UNITED STATES PATENT AND TRADEMARK OFFICE

APPLICATION NO.	FILING DATE	FIRST NAMED INVENTOR	ATTORNEY DOCKET NO.	CONFIRMATION NO.
10/626,652	07/25/2003	Scott Basyl Johnston	A4Z01	1402

Office Action Summary

DETAILED ACTION***Drawings***

FIGURE 3

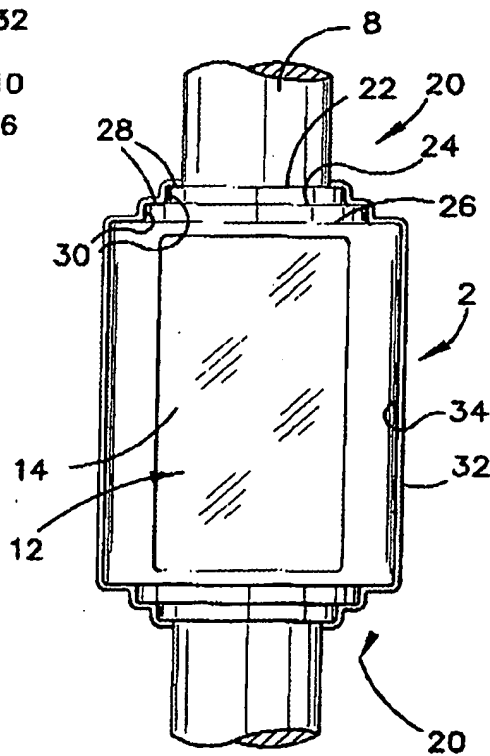
OK.
Approved.
Am 6/2/05
